Wichita-Sedgwick County Metropolitan Area Planning Department

August 16, 2016

RE: BZA2016-00035: City Sign Code Adjustment to increase square footage of sign on property zoned NR Neighborhood Retail.

SIGN 1 OPTION C

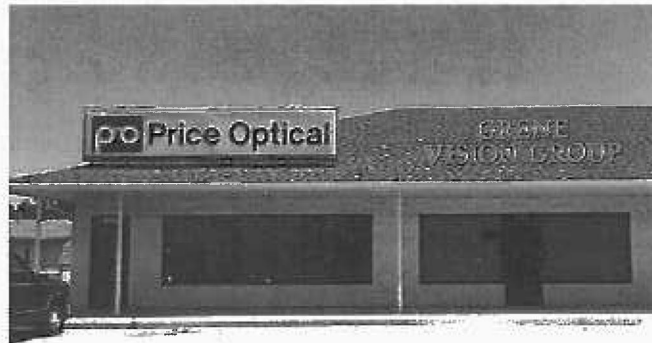
Our signatures below indicate that a Sign Code Adjustment to permit an adjustment to increase the size of the proposed sign to 36.3 square feet is **GRANTED**, subject to the following conditions:

- 1) The Administrative Adjustment is to allow a 36.3 square foot wall sign; all signage on the site shall otherwise conform to the Sign Code unless a separate adjustment or variance is approved.
- 2) The sign shall be in conformance with the approved elevation and site plan. The sign shall be permitted and installed within one year from the date of approval.
- 3) If the Zoning Administrator finds that there is a violation of any of the conditions of the Sign Adjustment, the Zoning Administrator, in addition to enforcing the other remedies set forth in the Sign Code, may, with the concurrence of the Planning Director, declare that the Sign Adjustment is null and void.
